# Technical BULLETIN

## 2007 PZ50W/FXW/GTW/MW/VTW Hard Starting in Extreme Cold Temperatures

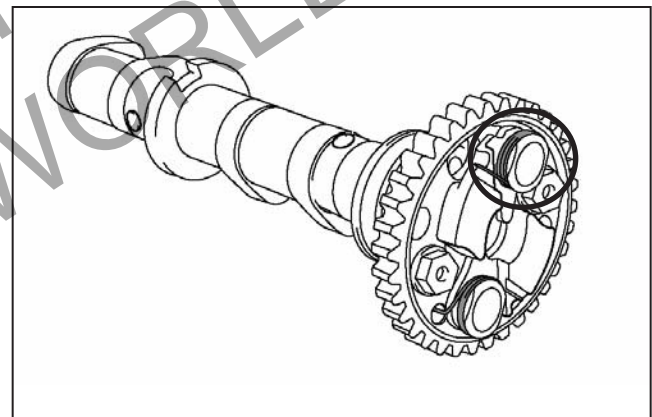
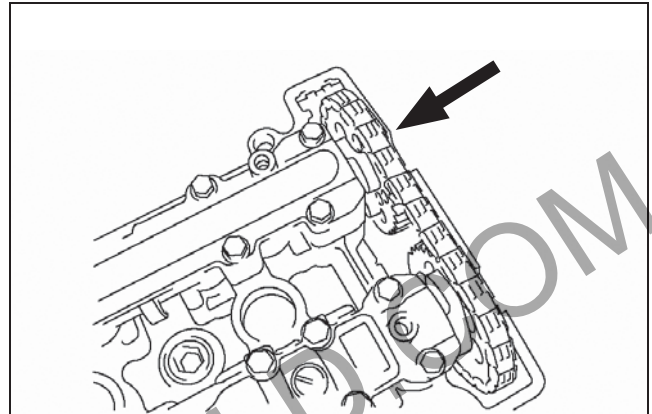
1. Remove the seat, fuel tank and any other parts (side panels, tank cover, and spark plug caps) to access the engine cylinder head cover.
2. Disconnect the negative (-) cable from the battery.
3. Remove the cylinder head cover.
4. Position the camshaft, by using the primary clutch to turn the engine in the normal direction of rotation (clockwise), to access the exhaust decompression spring.

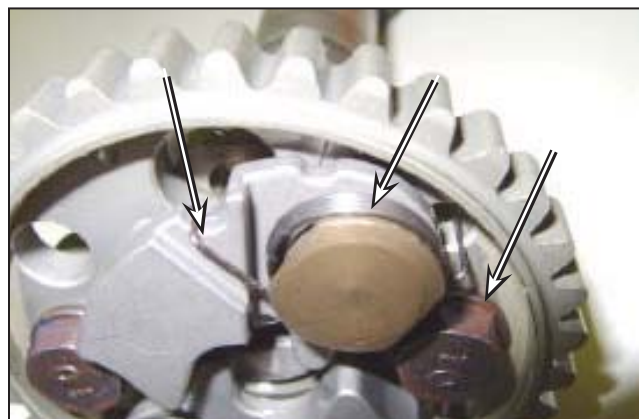
6. Remove the decompression spring as shown in the adjacent photo. Take care not to drop the spring into the engine.

7. Install the new decompression spring.

**NOTE:** Check that the spring is properly installed as shown in the adjacent photo.

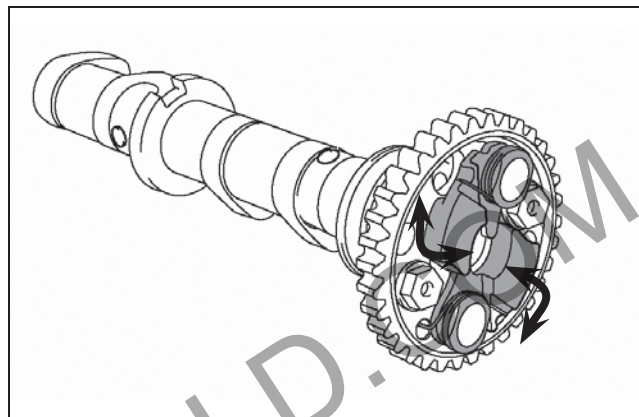
8. Using the primary clutch, turn the engine in the normal (clockwise) direction of rotation to access the other spring. Install the second spring.

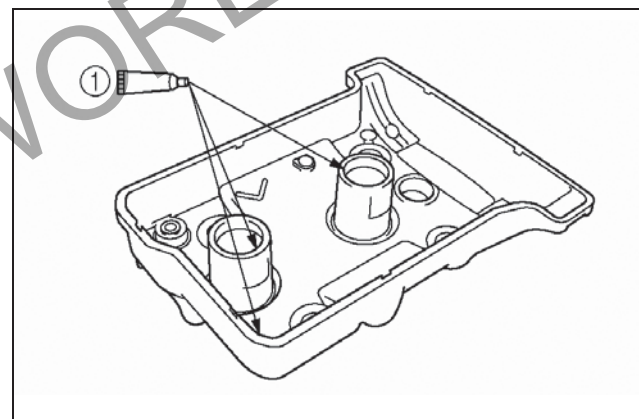
10. Re-install the cylinder head cover using the new gasket supplied in the kit.

Apply Yamabond 4 Motorsports to the cover ① surface and the mating surfaces of the cylinder head cover gasket and cylinder head ②.

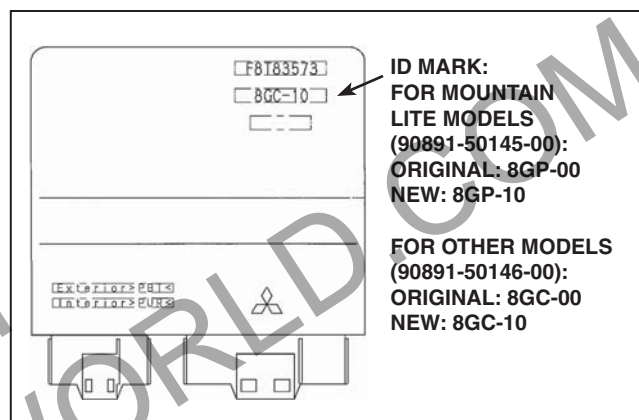
If you encounter an unfamiliar unit and you are unsure if the unit has been modified, check the ECU (see adjacent illustration).
